Section 2 Response to Comments

**Response to the
United States Environmental Protection Agency
Region IX
Letter Dated April 5, 2011**

Figure 1

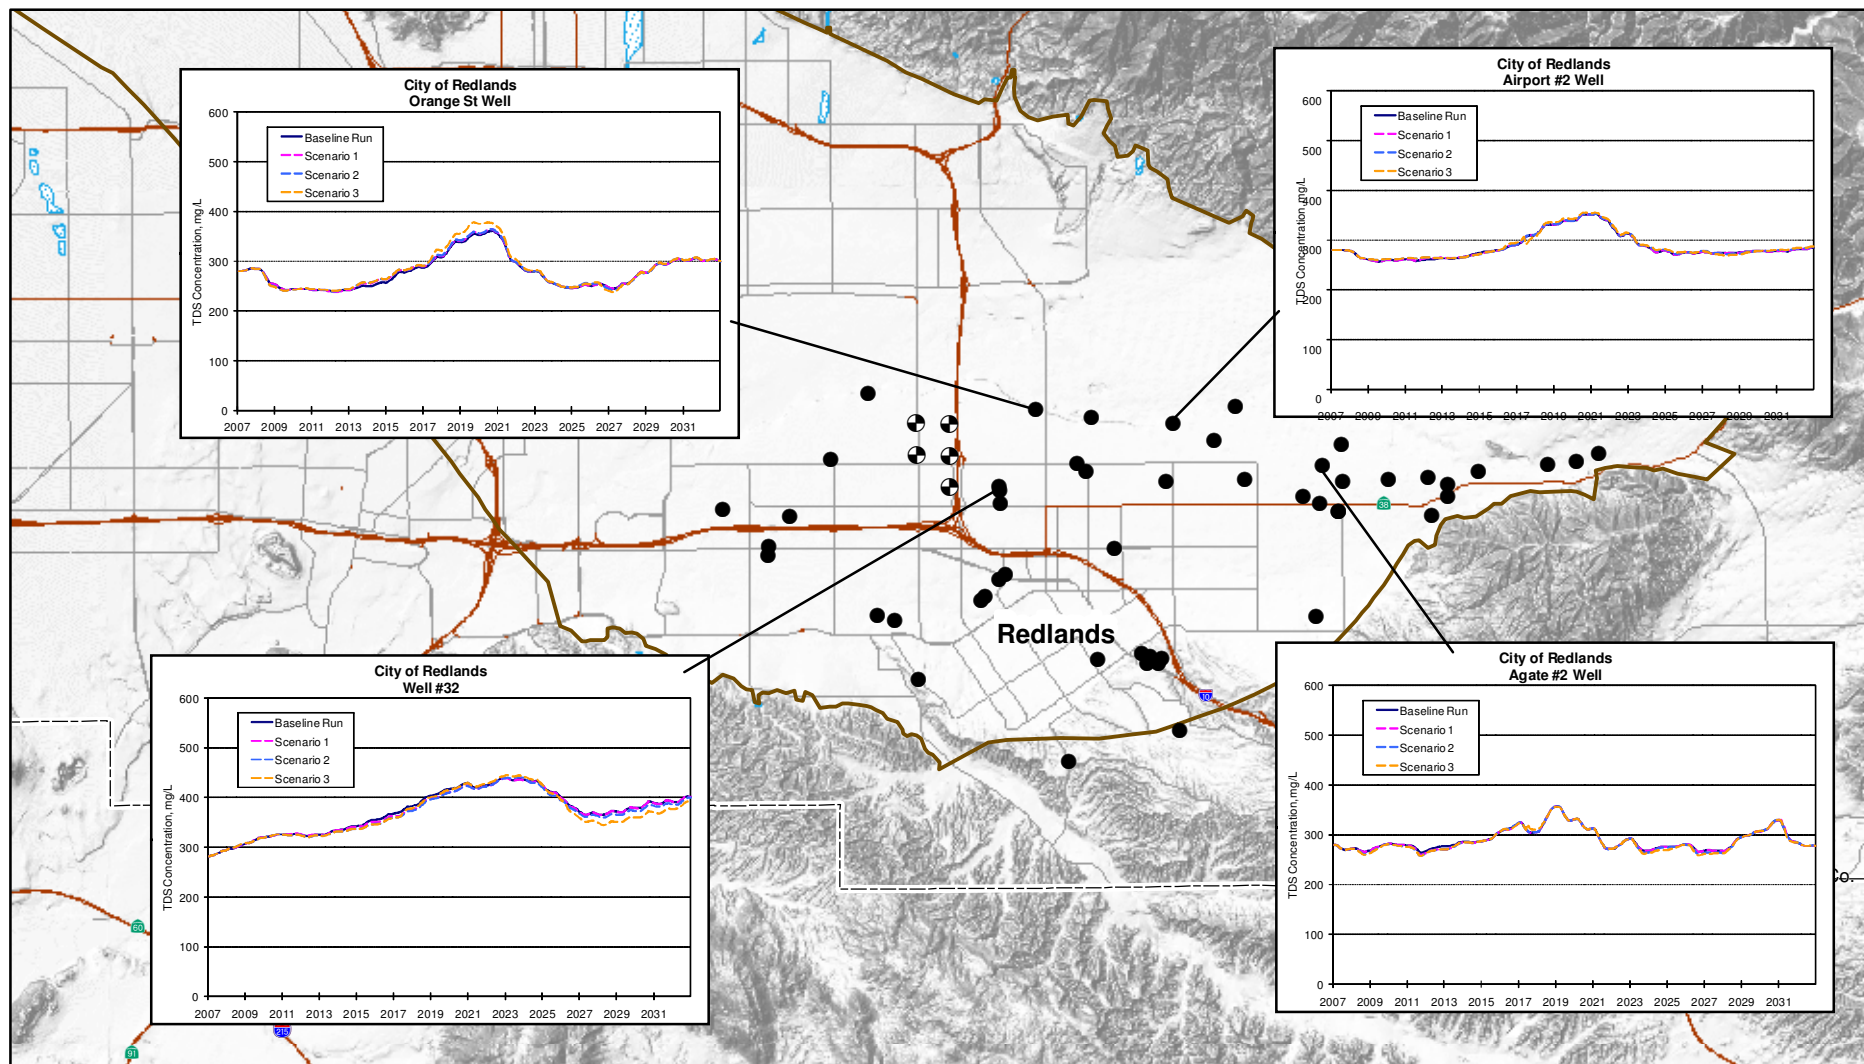
Model-predicted TDS concentrations for Scenarios 1 through 3 were found to be similar to those for the Baseline Run (No Project).²⁰ Plots of TDS concentration over time in the City of Redland's Well 32, Orange Street Well, Agate 2 Well and Airport Well 2 are shown on Figure 2 below. These concentration plots show the temporal variations in TDS concentrations due to hydrologic conditions, artificial recharge and groundwater pumping assumed under No Project and Project Scenarios 1 through 3. More importantly, Figure 2, along with Table 4.3 Of GEOSCIENCE 2010a (Draft SEIR/EIS Table 4.7-D), indicate that the Project will not impact the City's wells with higher TDS concentrations. In general, any future increases in TDS concentration in the Redlands area are related to changes that are predicted to occur with or without the Project such as agricultural use, residential irrigation, chemical processing, etc. Since the Project will not increase TDS concentrations in Redland's groundwater wells, the Project will not result in increased concentrations of TDS in treatment plant effluent.

FIGURE 4

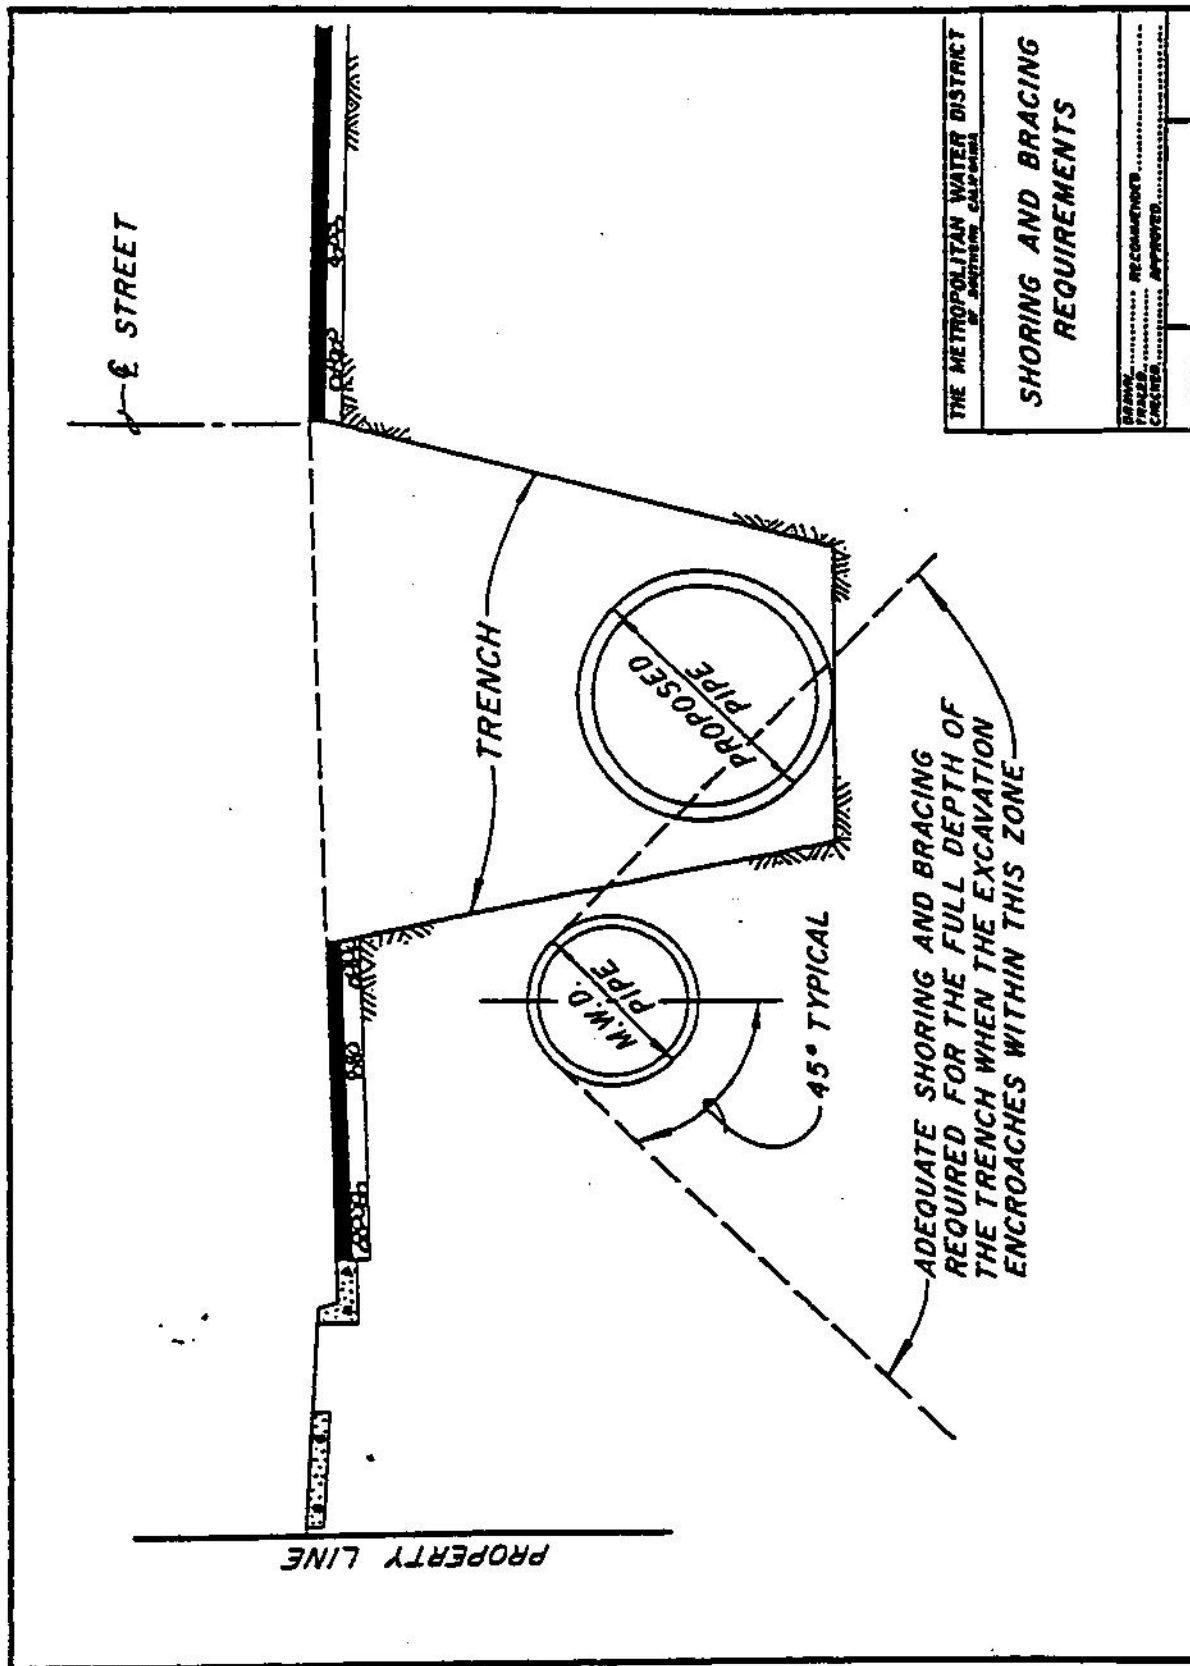
k. Adequate shoring and bracing is required for the full depth of the trench when the excavation encroaches within the zone shown on Figure 4.
